# CONVAIR

## COMMERCIAL CHANGE PROPOSAL

SPEC NO.: ZD- 30-005

MODEL: 30-5 (Convair "600")

MODEL 600 CARGO COMPARTMENTS  
COP #17A- INFORMATION SKETCH  
(NOT A PART OF SPECIFICATION LANGUAGE)

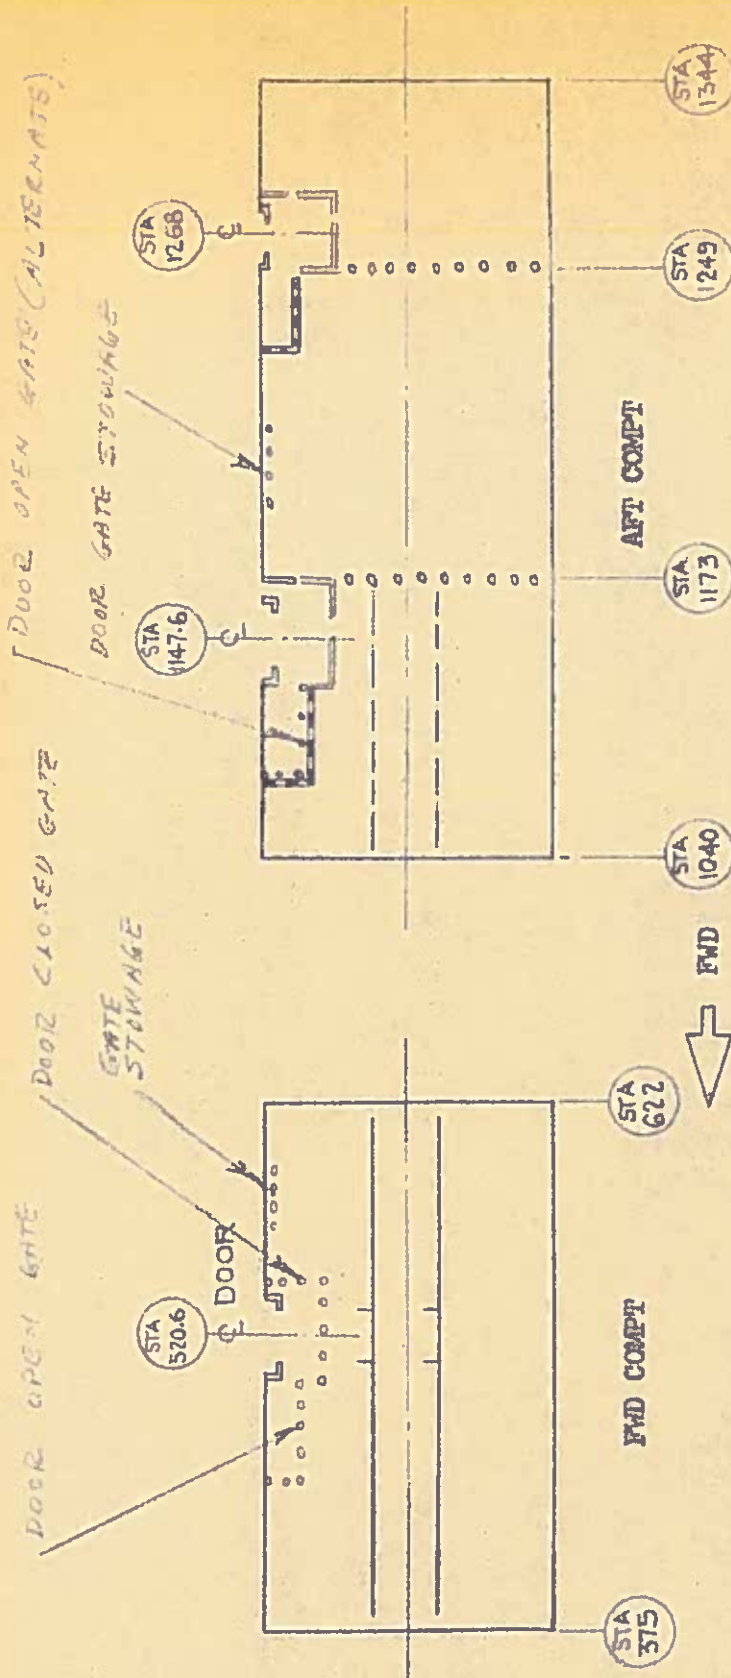
Paragraph 3.1.2.2 - TYPICAL LOADING SUMMARY will be revised to reflect cargo weight totals using weight figure of 12 lbs per cu ft density in a future specification revision after Customer acceptance of this proposal.

The design and operating objectives shall be in accordance with Attachment to Convair Letter No. 10-0-1767 (revised 2 June 1959).
